Sewall Wetland Consulting, Inc.

RE: 5637 East Mercer Way – Parcel #1924059312
City of Mercer Island, Washington
SWC Job#14-206

This letter is a response to questions in the ESA memorandums dated 10-17-19, regarding Parcel #1924059312

ESA Memorandum dated October 17, 2108

Wetland and Wetland Buffer Impact Site Plan

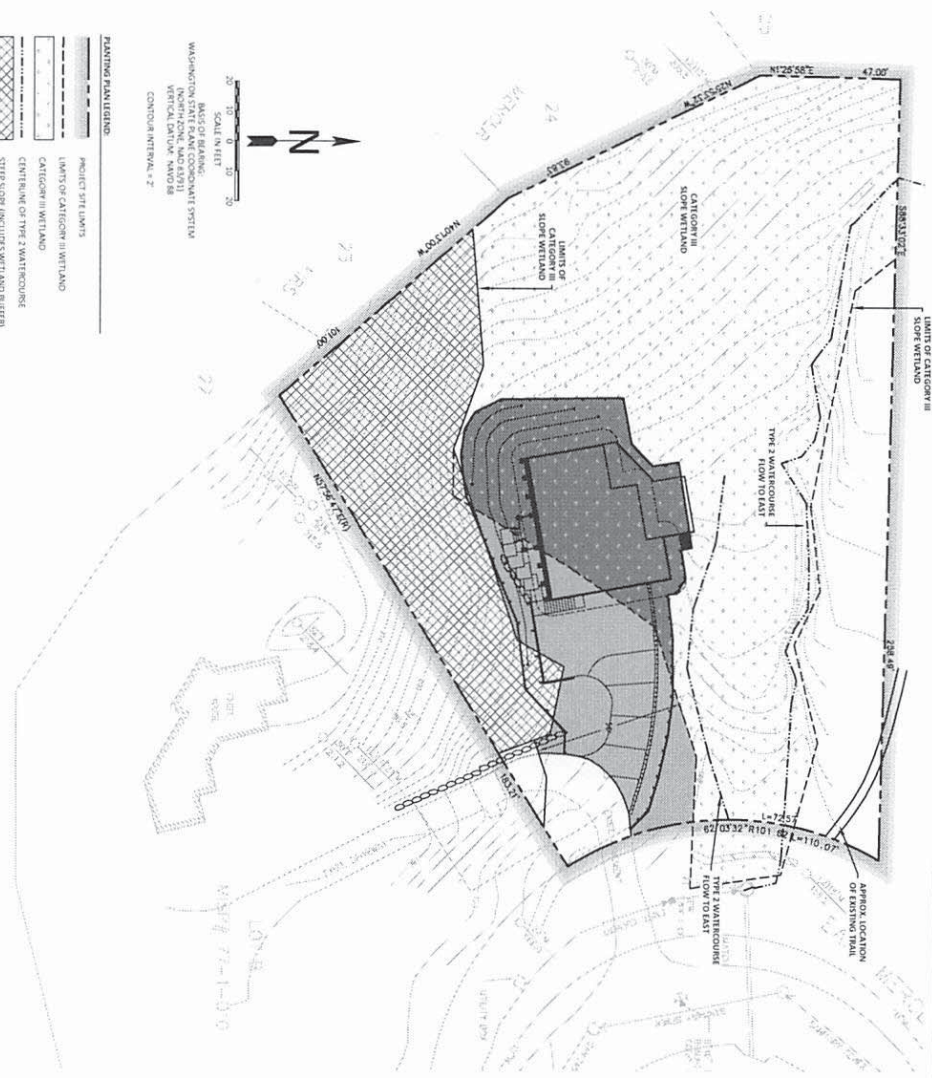
1. The March 8th CAR should indicate why the northeast corner of the building footprint is considered temporary and not permanent wetland impact.

2. Provide rationale to support the determination that decks will result in temporary, rather than permanent, wetland impacts.

3. The entire square footage of the northern deck should be considered as impact.

5. The applicant should provide detailed discussion and associated impact calculations, if applicable, of the proposed excavation and grading activities. Grading should be designated as permanent wetland impact and mitigated appropriately.

7. If the area encompassed by the perimeter fence or wall will be permanently disturbed, then appropriate mitigation should be implemented based on the impact area.

8. A house maintenance area should be calculated and mitigated.

9. An additional offset or paper buffer of 5 feet from the maintenance area is appropriate; impacts should be calculated and mitigation implemented.

10. Recalculate buffer impacts applying the 50-foot wetland buffer.

11. Include the northern retaining wall in the impact area calculation.

Response: The area of the northeast corner of the site is now considered a permanent impact on the attached revised mitigation plan.

Response: Although we are proposing to replant the area under the decks, for the purpose of the impact calculations, we now are including

the decks as an impact. This area will now be replanted with slough sedge as a mitigation action

Response: As described in the previous response, this area is now considered an impact as requested.

Response: As requested, all structures and grading are now considered a permanent impacts as shown on the attached Wetland and Buffer Impact Site plan dated revised 12-17-18.

Response: The retaining wall is now considered a permanent impact.

Response: A 5' BSBL area has been calculated as an impact as requested.

Response: A 5' BSBL area has been calculated as an impact as requested.

Response: The total wetland buffer impact area using 50' has been calculated as requested, and results in 3,479sf of buffer impact.

Response: The northern wall has been calculated as a permanent impact.

Planting Plan, Notes, Details, & Monitoring Plan

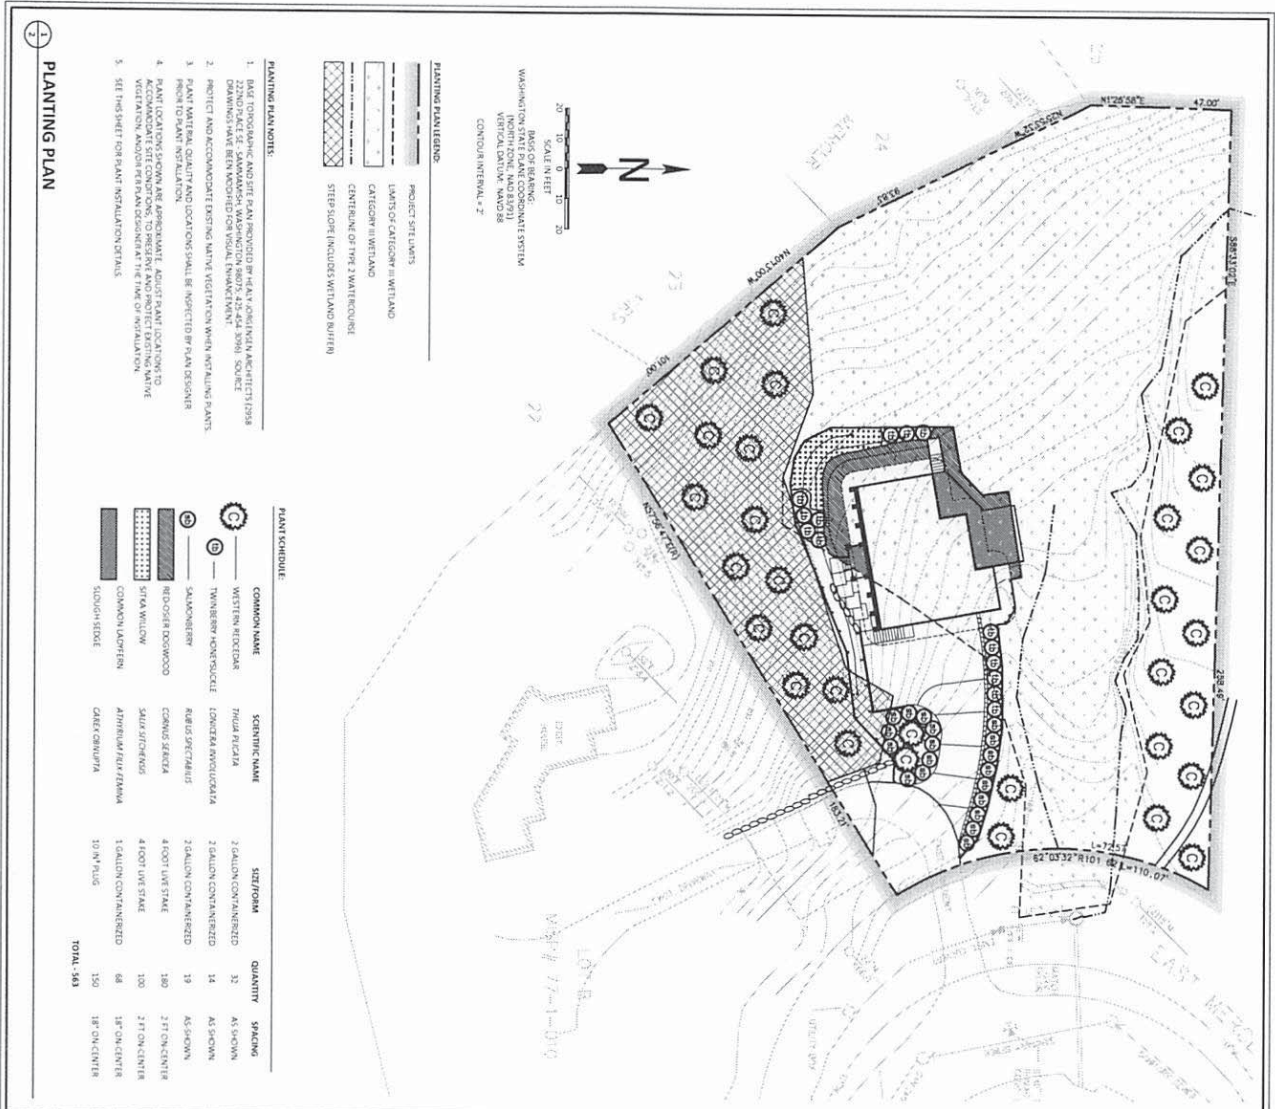
14. Mitigation discussion within the CAR should clarify the type of onsite mitigation.

15. Mitigate onsite to compensate for permanent buffer impacts.

Response: The mitigation for the project will consist of two actions;

1. On-site buffer enhancement to include under planting the existing buffer with conifers, as well as replanting areas that are graded

and under the elevated decks. This is depicted on the attached Critical Area Enhancement Plan revised to 1-24-19.

Response: On-site wetland buffer enhancement includes removal of any blackberry and under planting with conifers as depicted on the attached Critical Area Enhancement Plan revised to 1-24-19.
